ECE/TRANS/WP.29/GRE/2009/21
16 January 2009

Proposal for draft 01 series of amendments to Regulation No. 98
(Headlamps with gas-discharge light sources)

Submitted by the expert from the Working Party "Brussels 1952" */

The text reproduced below was prepared by the expert from the Working Party "Brussels 1952" (GTB) in order to change the basis for the photometric requirements from 12.0 V to 13.2 V. The modifications to the existing text of the Regulation, including draft Supplement 12 and draft Corrigendum 2 to Supplement 9 to Regulation No. 98, are marked in bold or strikethrough characters.

Figure A: Spherical Coordinate Measuring System

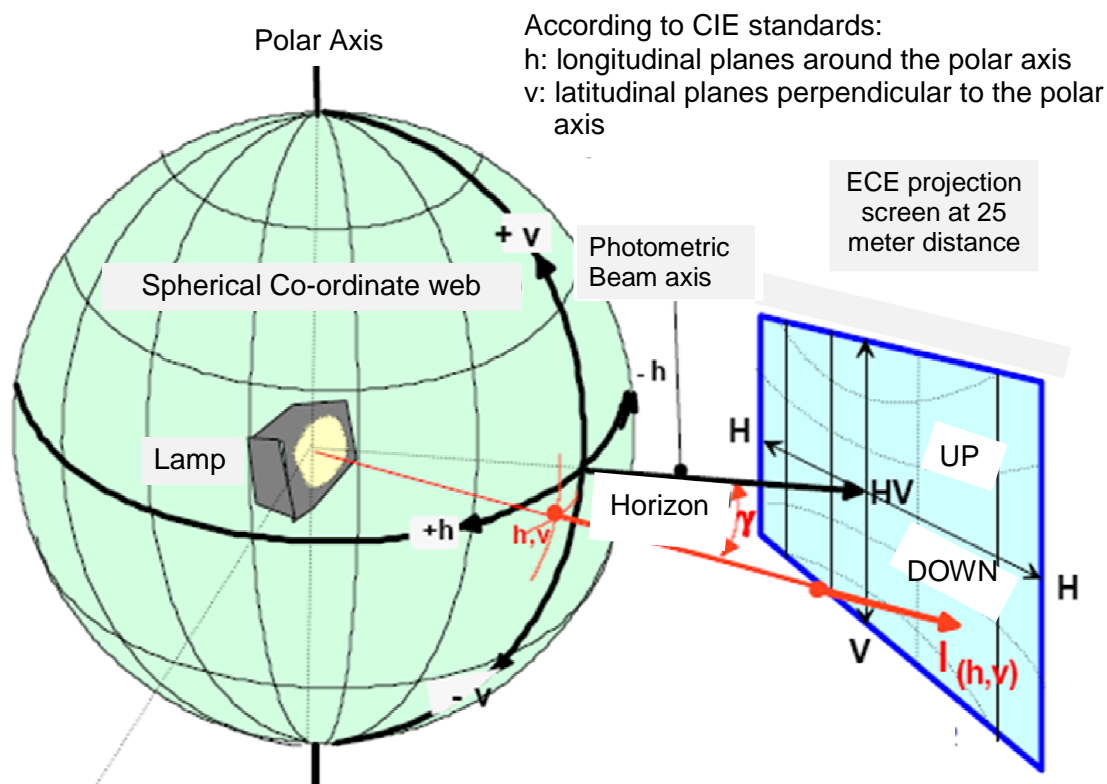
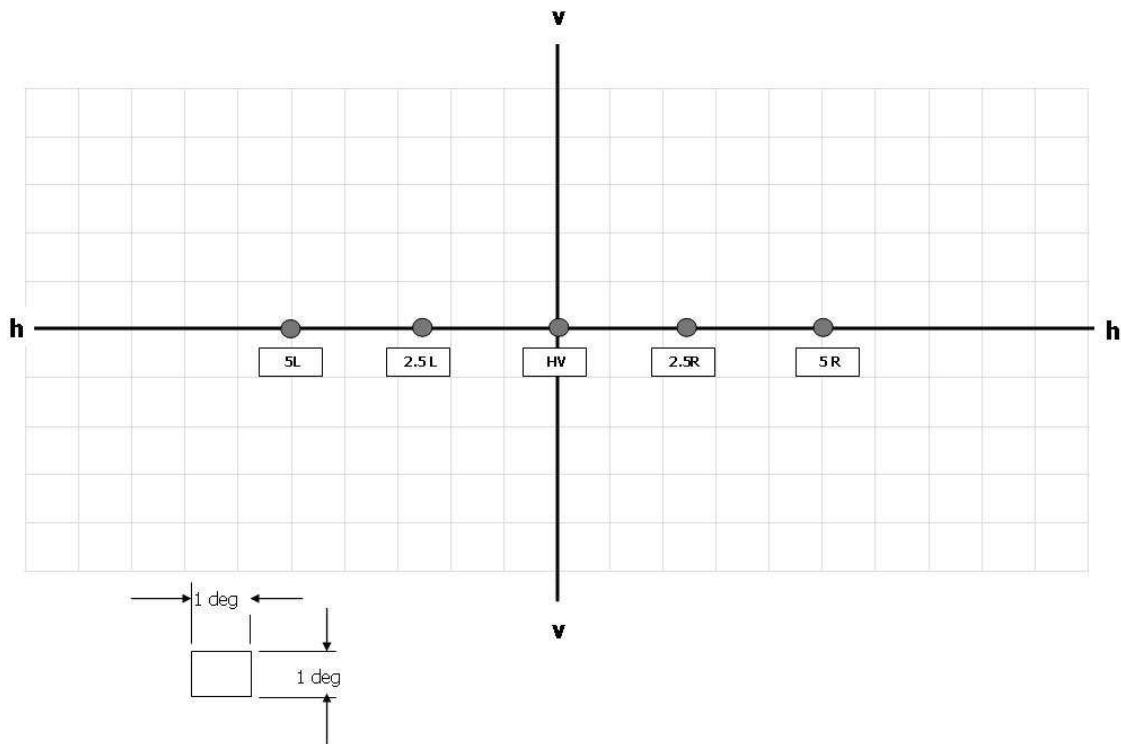
Annex 3, amend to read:

**SPHERICAL COORDINATE MEASURING SYSTEM
AND TEST POINT LOCATIONS**

$$E_{25m} = I_{(h,v)} \times \cos \gamma / r^2$$

h-h : horizontal plane) passing through
 v-v : vertical plane) focus of headlamp
